Major Site Plan Application

RE: Major Site Plan Application - Resubmittal
H2OBX RV Resort
Currituck County, North Carolina

POST DEVELOPED DRAINAGE AREA MAP
H2OBX RV & WATERPARK RESORT
H2OBX, LLC
CURRITUCK COUNTY
POPLAR BRANCH TOWNSHIP
NORTH CAROLINA

SITE & LANDSCAPING PLAN
H2OBX RV & WATERPARK RESORT
H2OBX, LLC
 POPLAR BRANCH TOWNSHIP
 CURRITUCK COUNTY
 NORTH CAROLINA

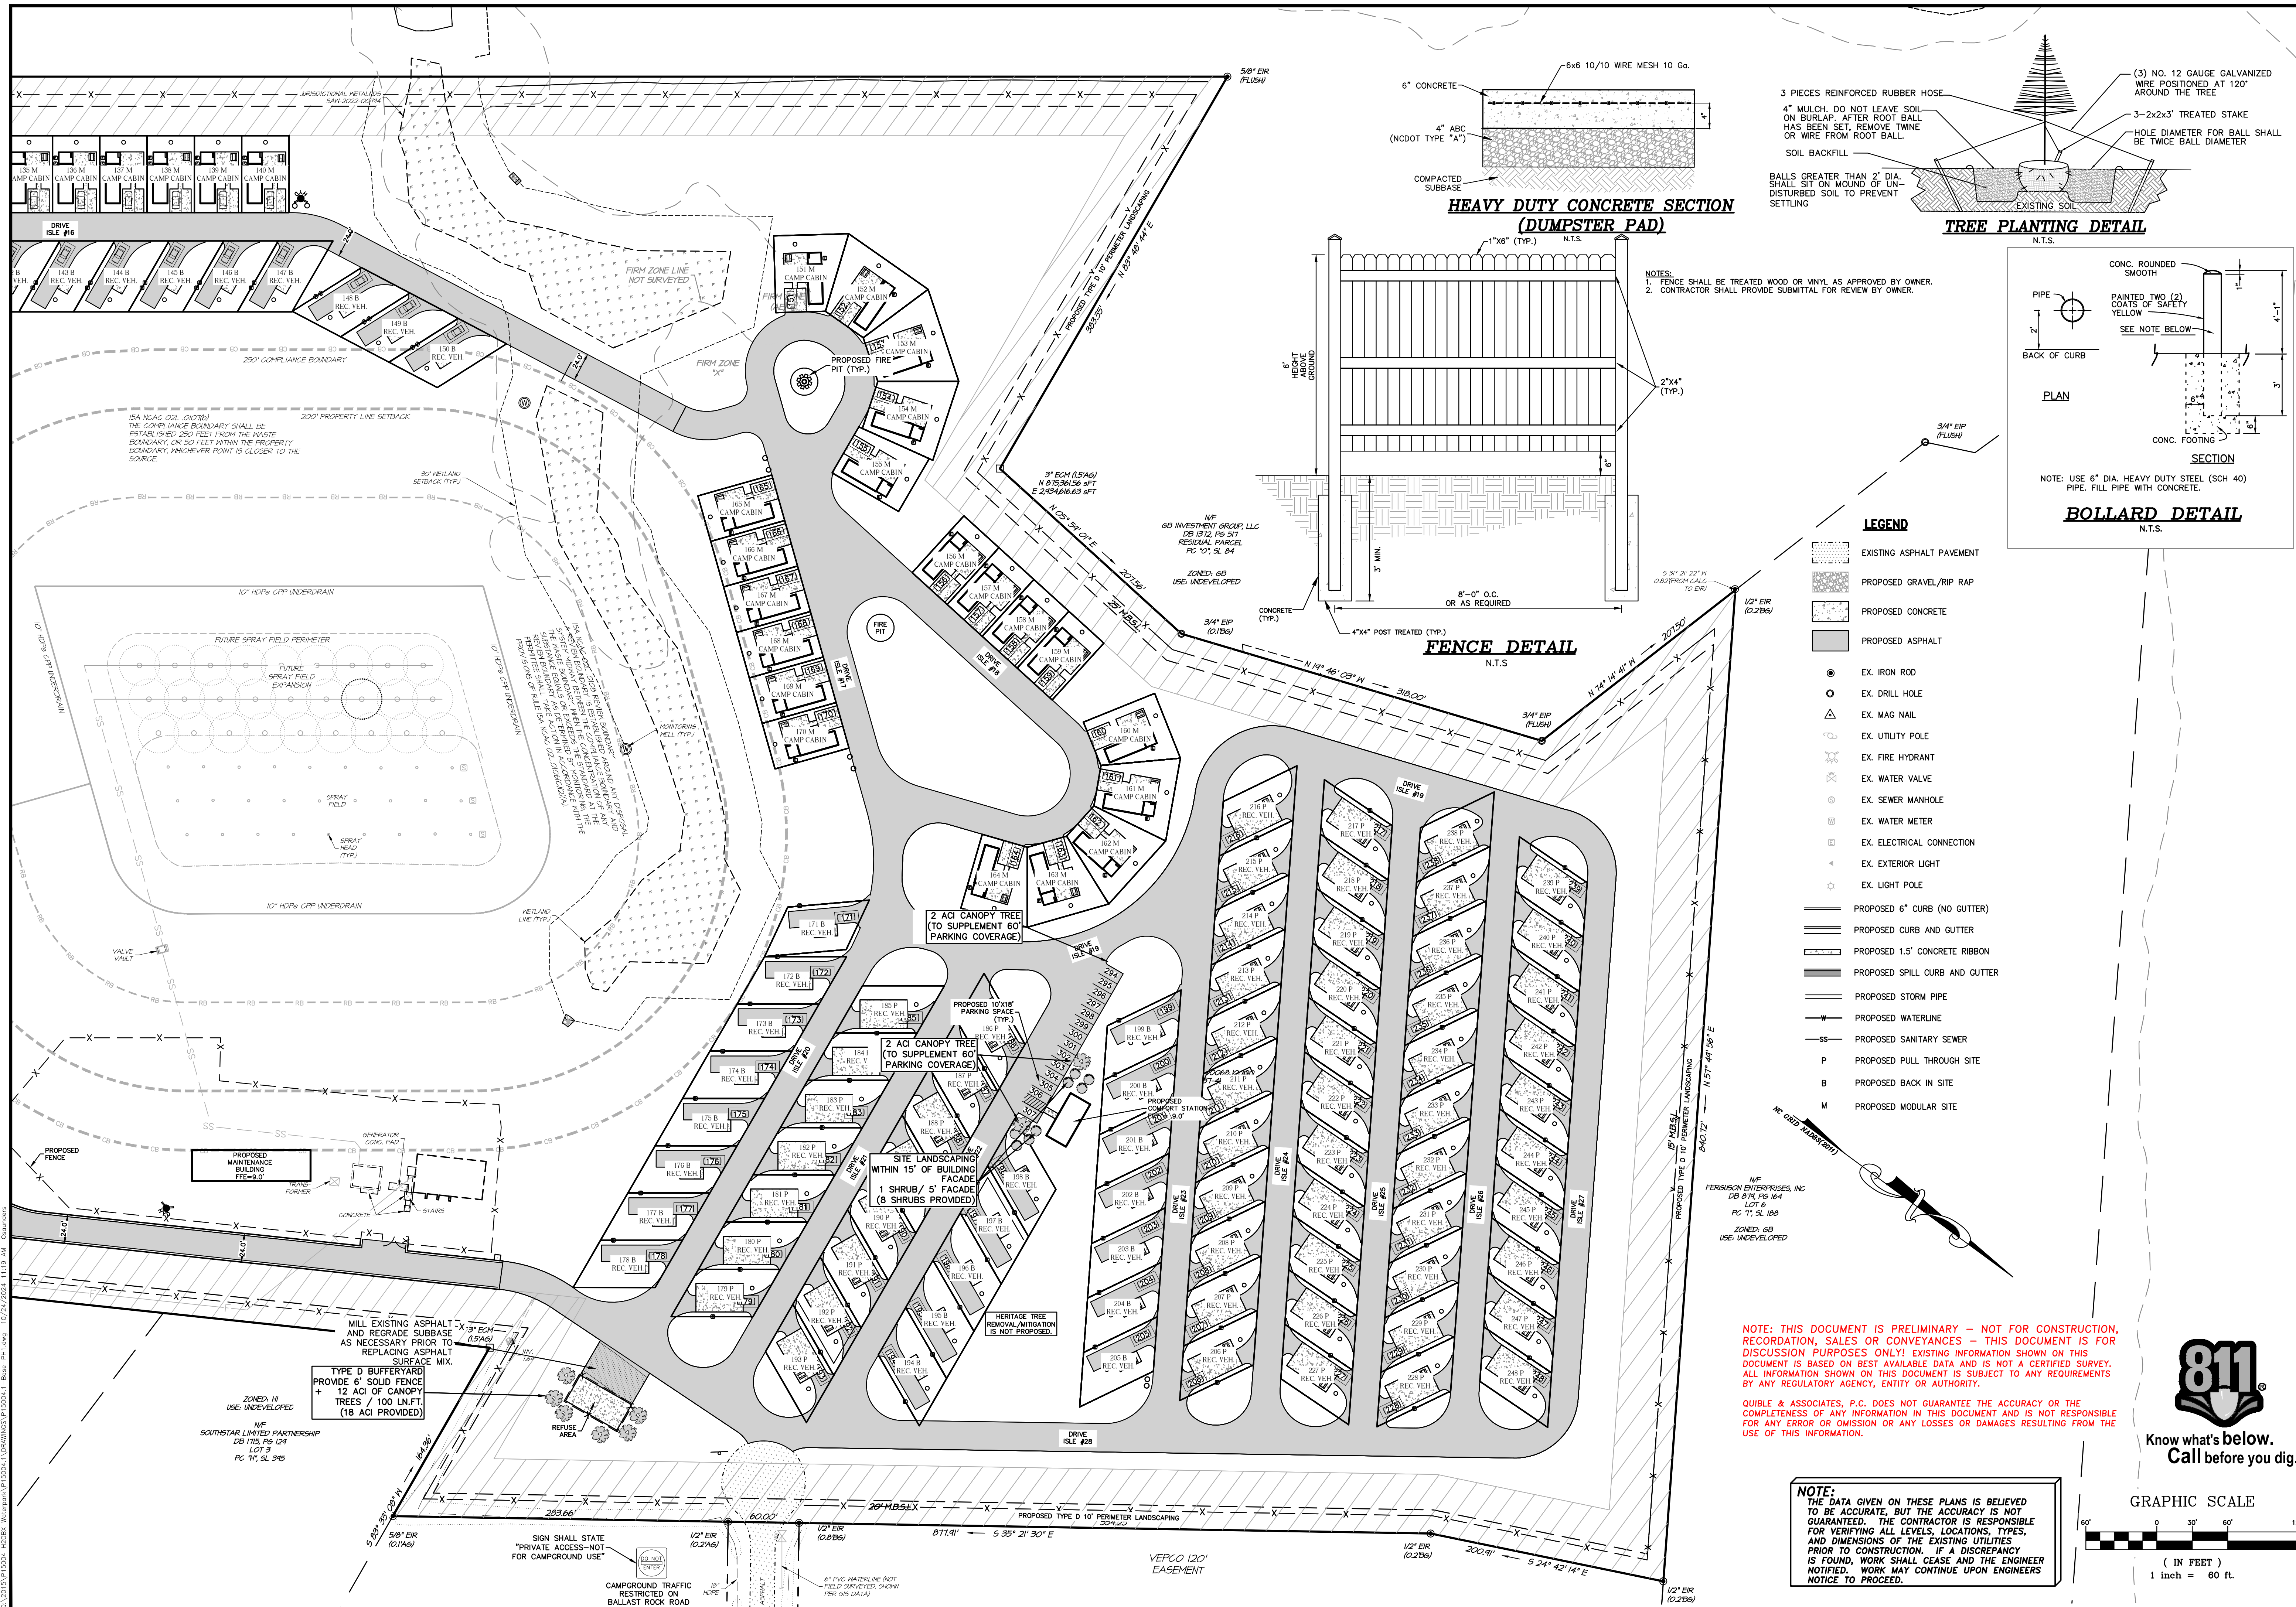
9. Please number and delineate all parking spaces, and provide overall density calculations.
Acknowledged. Numbered and delineated parking spaces along with overall density calculations are shown on sheets 4 & 5.

10. Provide and designate the type of each campsite per UDO Section 4.2.4.J(3)(g)(vii).
 - a. Include percentage of camping cabins or alternative camping units *Acknowledged. See sheet 4 for percentage calculations.*

- b. Include seasonal or short-term designation for each campsite *Acknowledged. See note on sheet 4 stating the maximum number of seasonal campsites.*

11. Please provide a canopy tree within 60' of all parking spaces. *Acknowledged. Please see the proposed landscaping shown on sheets 4&5 showing a canopy tree within 60' of all parking spaces.*

12. Provide more detail on required buffers and landscaping, including locations, and plant types. *Acknowledged. Please see the required buffers, landscaping, and planting schedule shown on sheets 4 & 5.*

14. Consider installation of bike racks where appropriate. *Acknowledged. Bike racks have been shown on Sheet 4 adjacent to the amenity area.*
15. Dumpster pad must be on 6" thick concrete. Include detail on plan. *Acknowledged. Please see the concrete dumpster pad on sheet 5.*

17. Are there any heritage trees currently on the property? Provide verification *WithersRavenel staff visited the site on 10/14/24 and field verified that there are no Heritage Trees within the proposed limits of disturbance. A note has been added to Sheet 4 & 5 to state "HERITAGE TREE REMOVAL/MITIGATION IS NOT PROPOSED"*

1. Indicate needed hydrant impact protection where no curb protection is present. *Acknowledged. Please see sheets 4&5 which show proposed bollards around all hydrants where there is no curb protection.*
2. Proposed maintenance building will need a hydrant within 400ft of all points on building if no sprinkler system installed. *Acknowledged. A fire hydrant has now been provided interior to the maintenance yard to protect the maintenance building and existing WWTP building. It is understood that a knox box will be required for access to the proposed security fencing.*
3. Knox Box will be required for emergency access to all structures. *Acknowledged.*
